# **RANCHO SANTIAGO COMMUNITY COLLEGE DISTRICT**

## **ADDENDUM NO. 03**

**Bid #1456 CAMPUS ENTRANCE IMPROVEMENTS PROJECT  
at  
SANTA ANA COLLEGE**

## DSA ADDENDUM NO: 01 & 02

**SITE DEMOLITION PLAN**

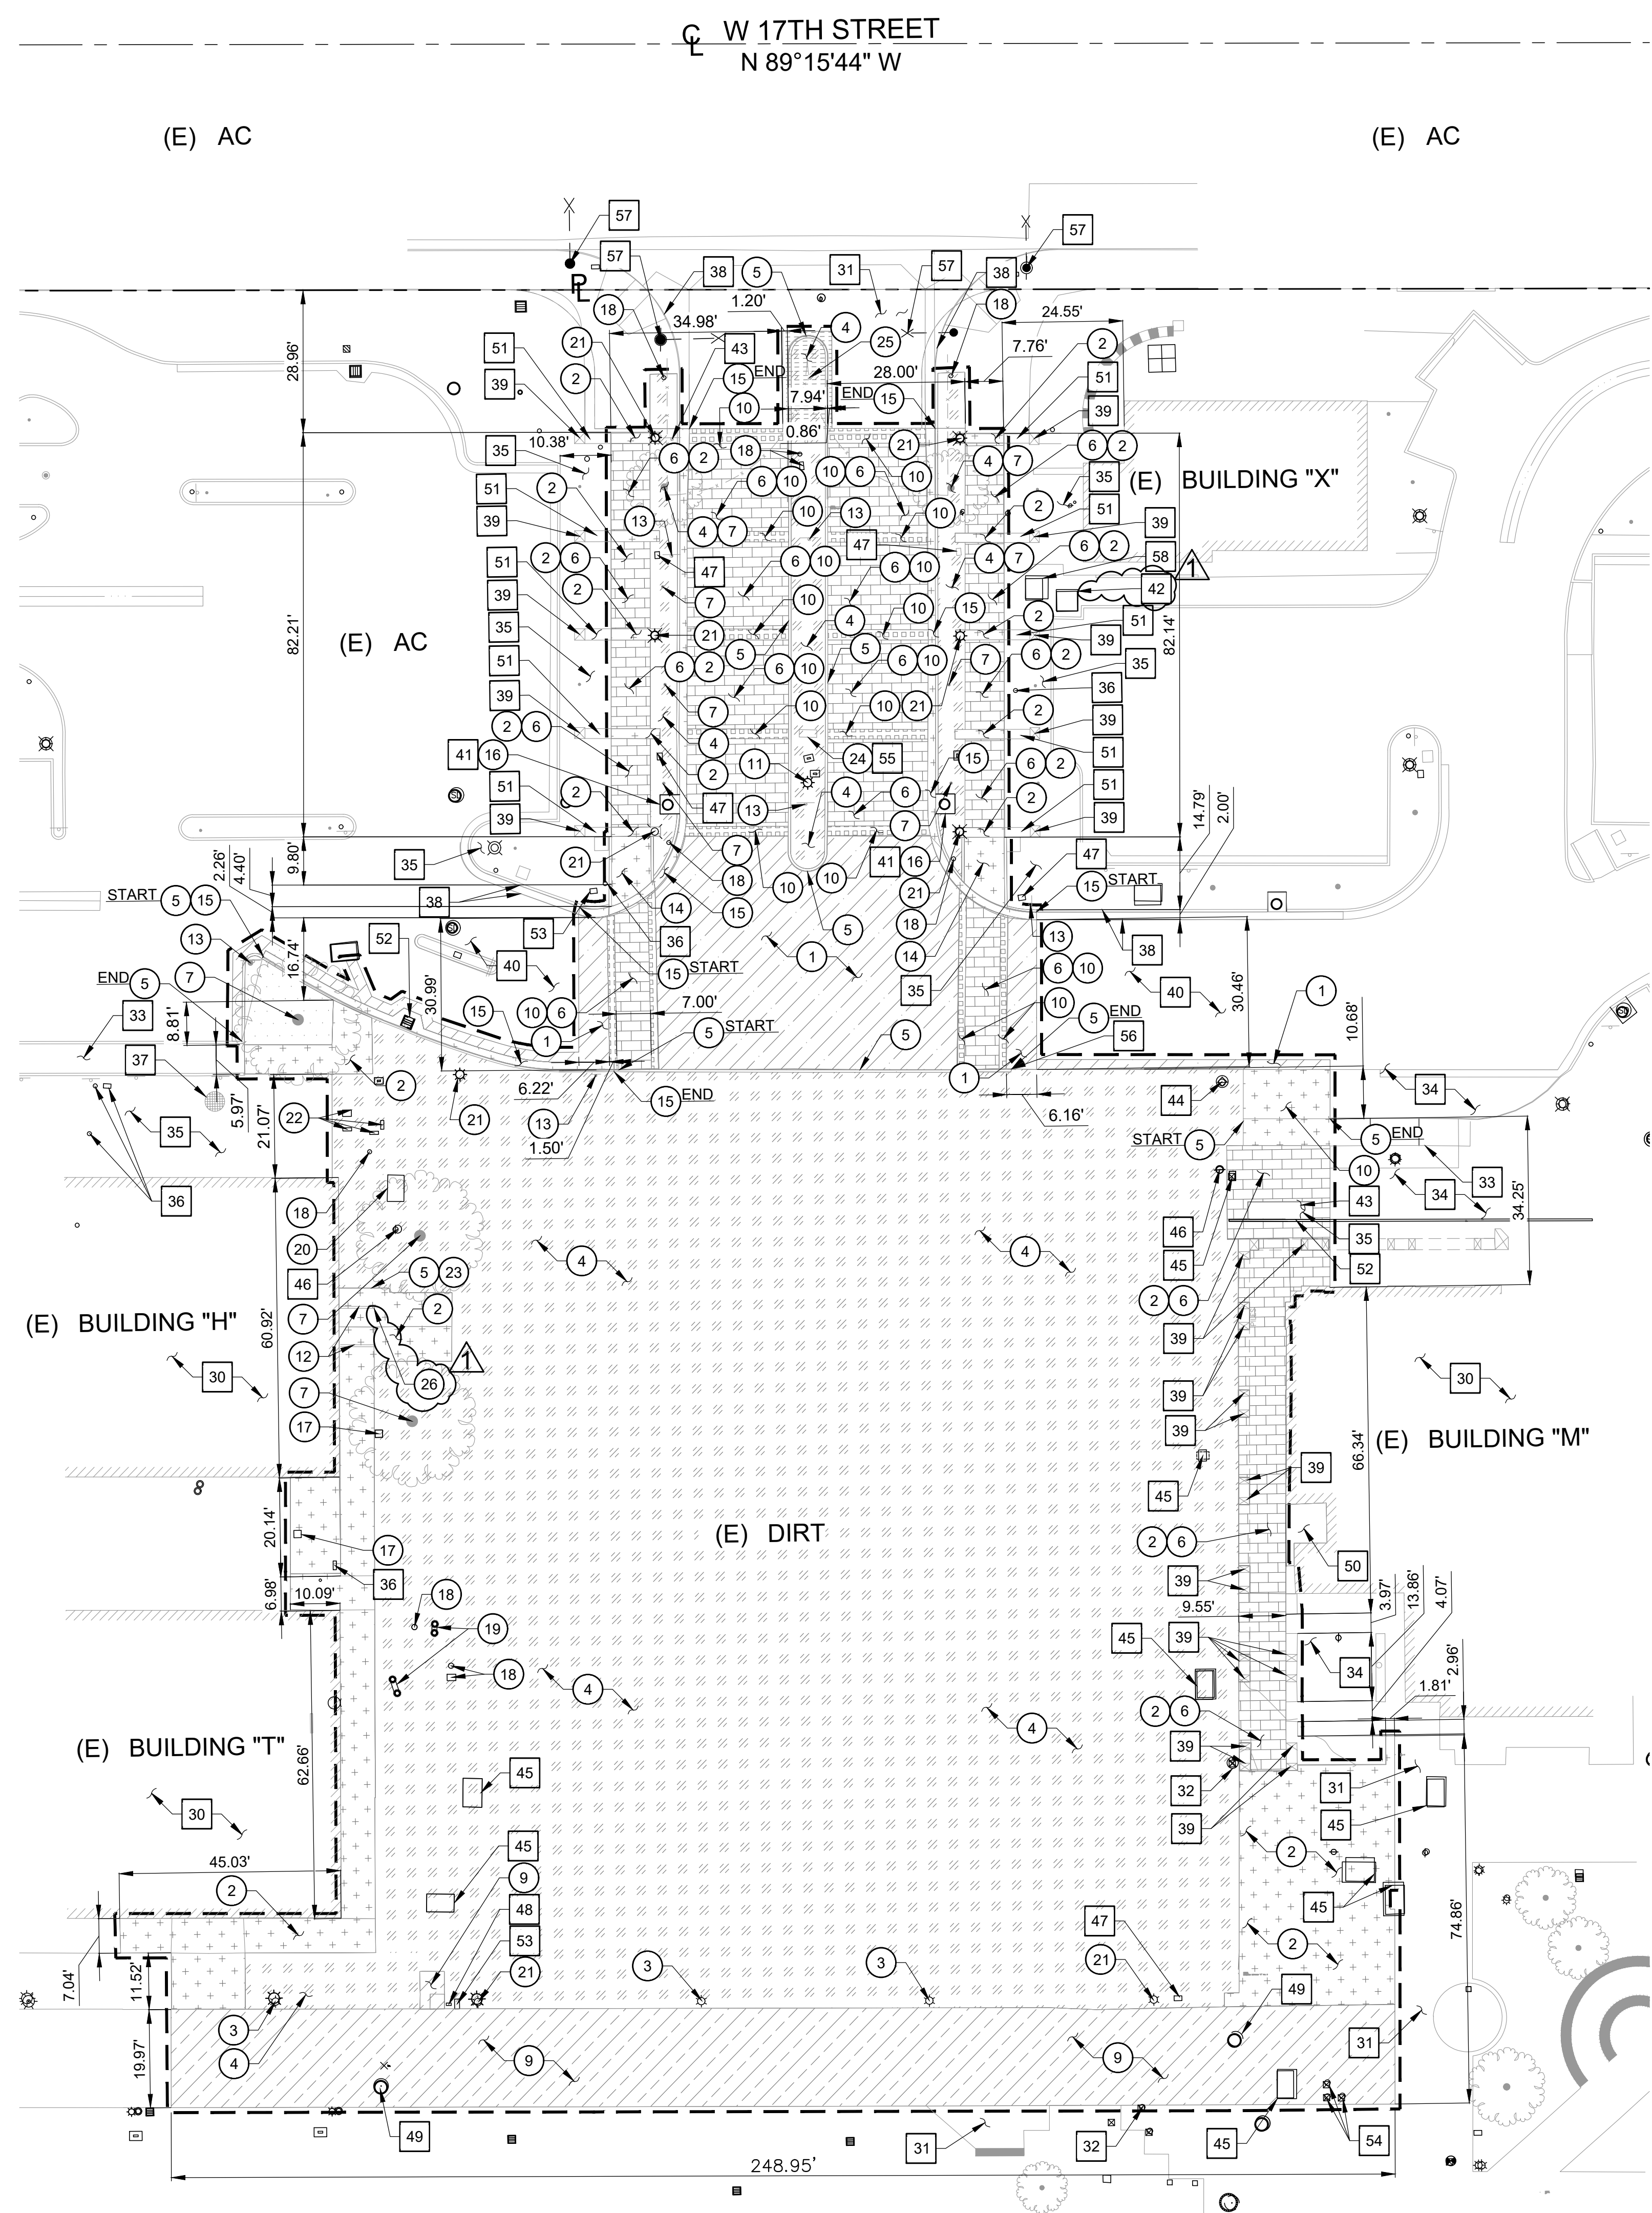
- A. CD-1.0, Site Demolition Plan: Revised removal note #11, to now state: *“remove and salvage existing camera and light pole and demolish its foundation in its entirety. Reinstall existing camera and light pole onto new foundation after construction of new curb median.”*

- B. CD-1.0, Site Demolition Plan: Revised removal note #12, to now state: *“remove, salvage, and relocate existing exterior cane detection rails. Reinstall and attach cane detection rails at its original location per architectural drawings.”*

- C. CD-1.0, Site Demolition Plan: Added removal note #26 on the site plan adjacent to Building “H” to indicate: *“remove, salvage and reinstall existing ADA door opener bollard with push plate and its conduit. Reinstall door opener bollard at its original location and adjust to new pavement grade as necessary.”*

- D. CD-1.0, Site Demolition Plan: Revised protect-in-place note #42, to now indicate: *“protect in place existing electrical vault.”* Added the protect-in-place note #42 on the site plan near and below to Building “X”.

- E. CD-1.0, Site Demolition Plan: Removed protect-in-place note #59 in its entirety, (*protect in place existing electrical vault*).
